ZAYO'S PRINEVILLE TO RENO PROJECT

CPUC MINOR PROJECT REFINEMENT FORM

RFI 338-340

AK - ALTURAS TO JUMPER RIDGE RD

VIEWPORT - 70

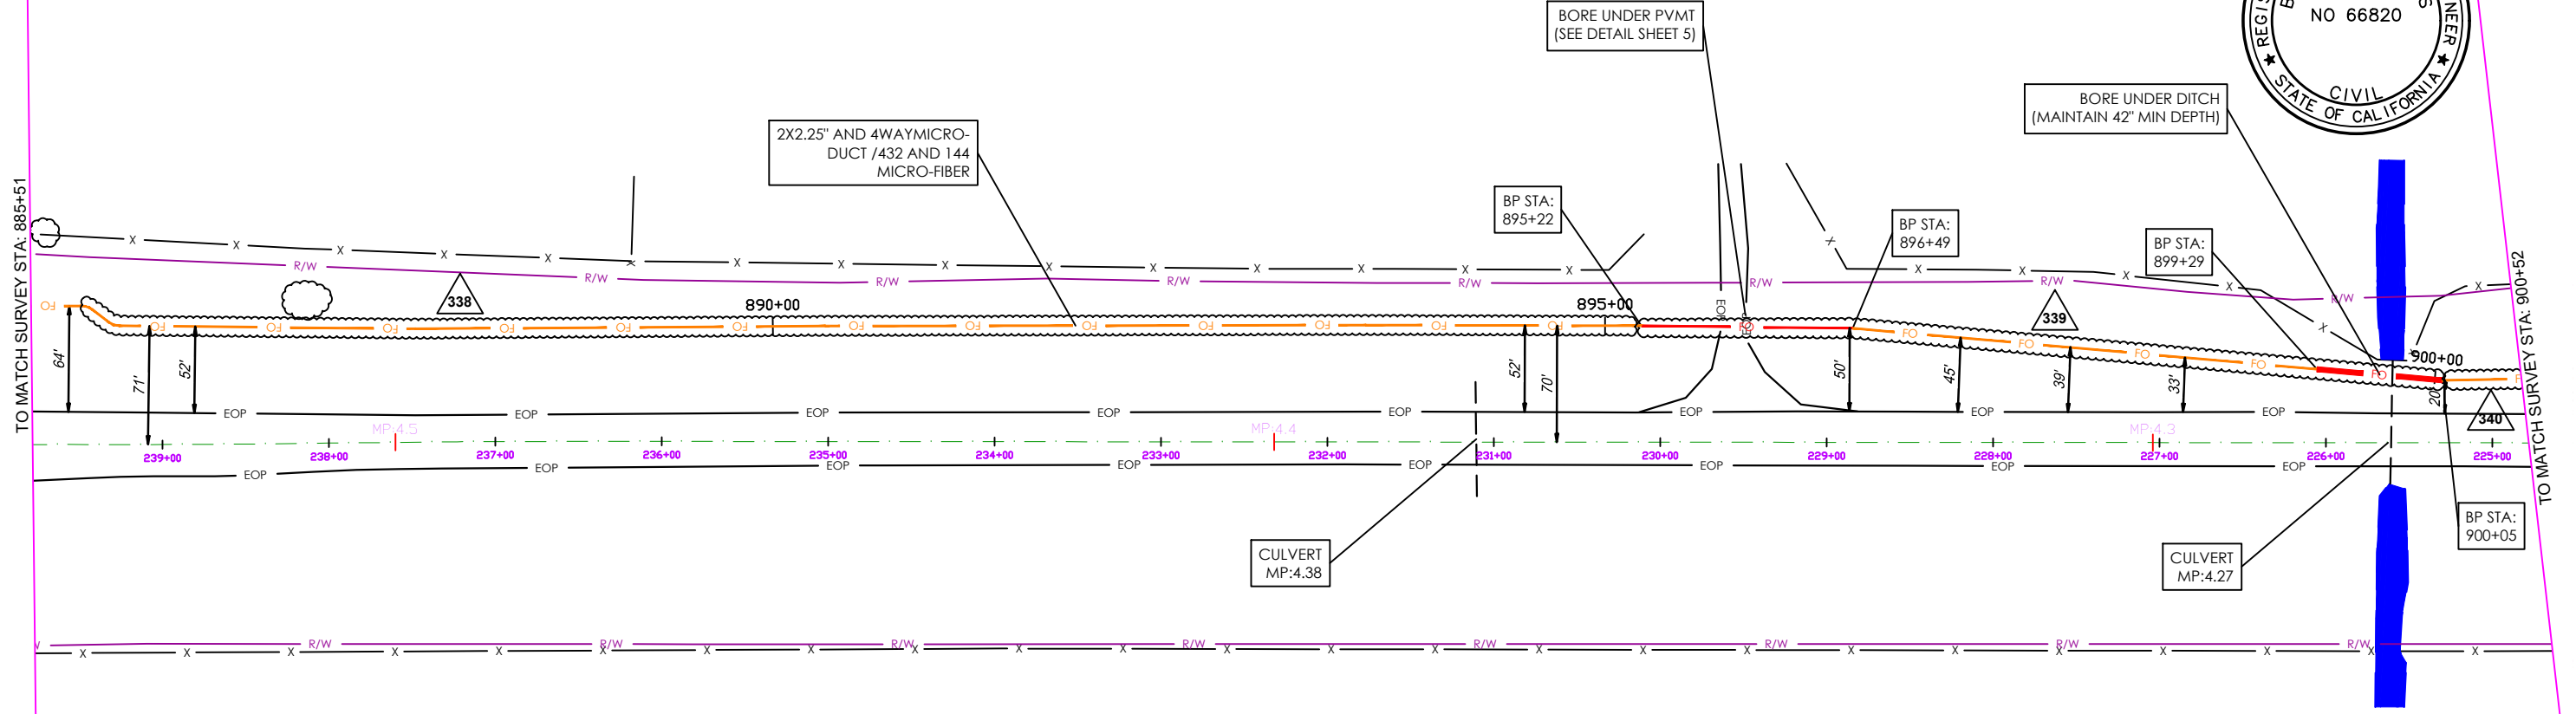
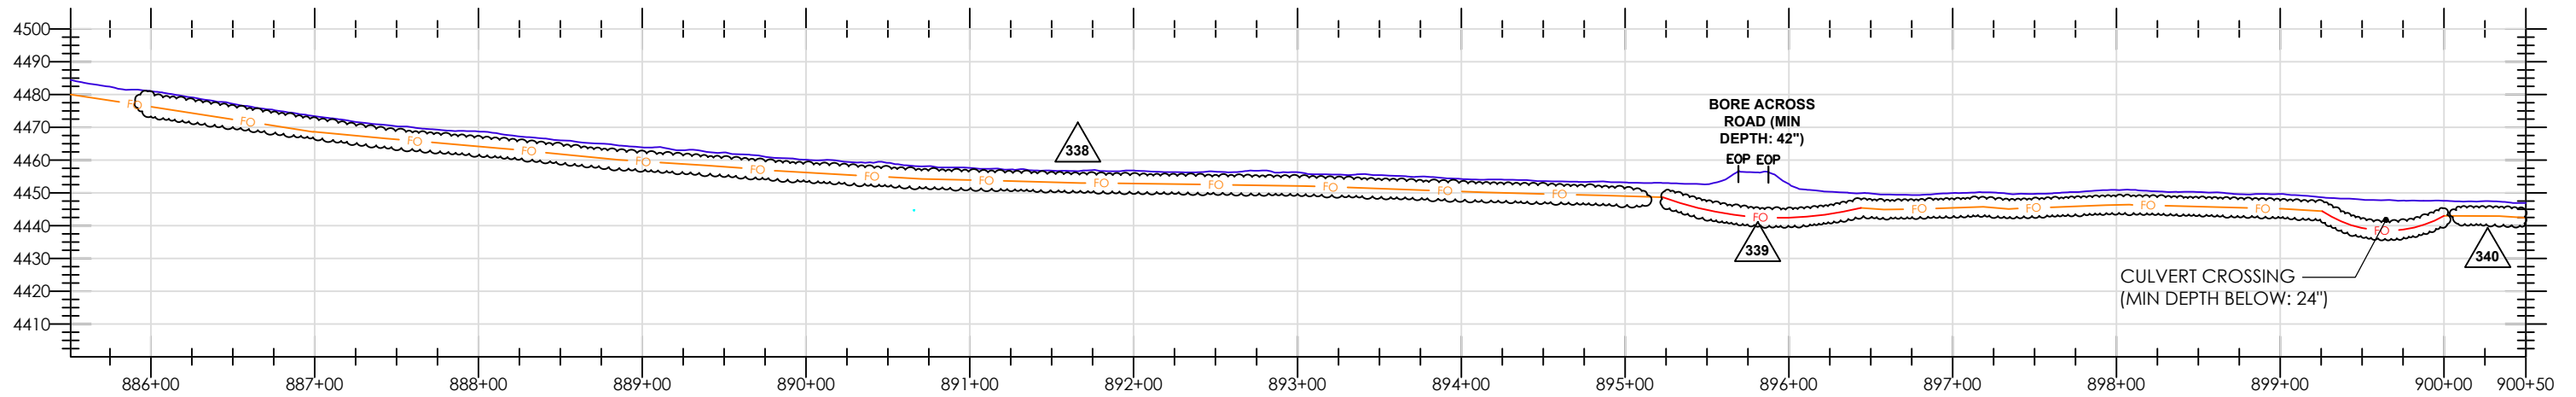
CAUTION RIGHTS-OF-WAY ARE DEPICTED BASED ON LATEST DOT RECORDS AVAILABLE. IF FURTHER ACCURACY IS REQUIRED, LAND SURVEYS WILL BE NECESSARY NOTES: FOR TRAFFIC CONTROL REFER TO 2023 CALTRANS STANDARDS AND LATEST EDITION OF CAMUTCD	RFI NO. 0338 MOVE R/L TO 52' FROM EOP TO BE BETWEEN NOT SHOWN FENCE AND BOULDERS	12/10/2024
	RFI NO. 0339 DEVIATE R/L AT STA 896+44 TO 50' OFF EOP AND ANGLE R/L TO 20' OFF EOP AT STA 900+04	10/16/2024
	RFI NO. 0340 DEVIATE R/L FROM 20' TO 30' FROM EOP TO AVOID FENCE STA 900+04 TO 905+88	10/16/2024

VIEWPORT - 71

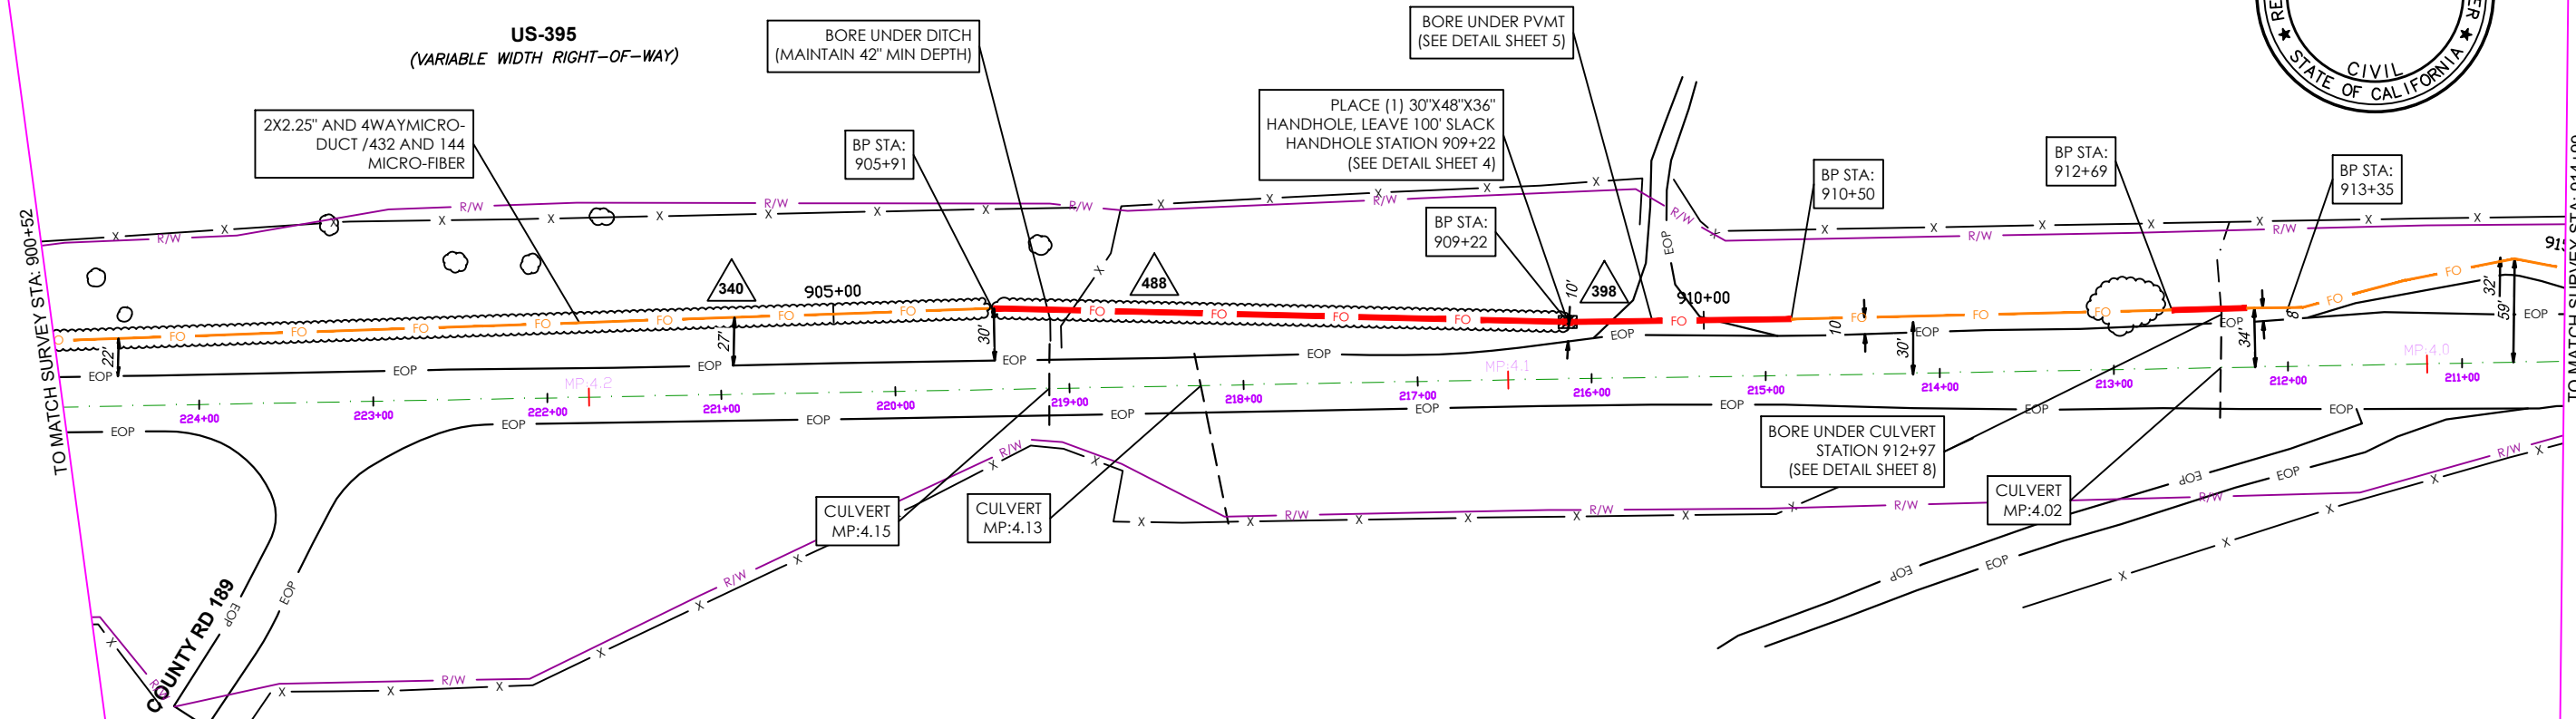
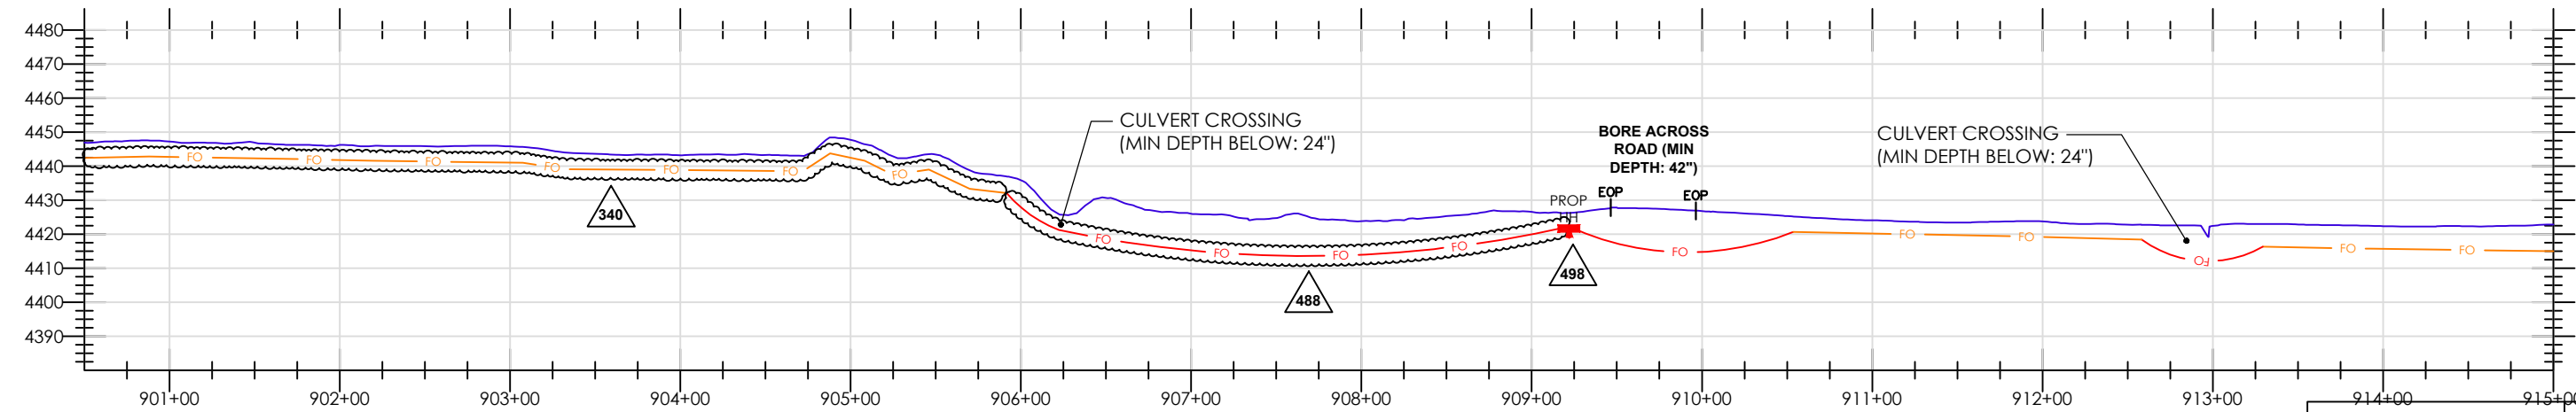
RFI NO. 0398 MOVE HH FROM STA 907+05 TO 909+33	12/10/2024
RFI NO. 0340 DEVIATE R/L FROM 20' TO 30' FROM EOP TO AVOID FENCE STA 900+04 TO 905+88	12/10/2024
RFI NO. 0488 CHANGE TO BORE DUE TO WETLANDS. START 10' FROM EOP AT STA. 909+33 TO 30' FROM EOP AT STA 905+88.	12/10/2024
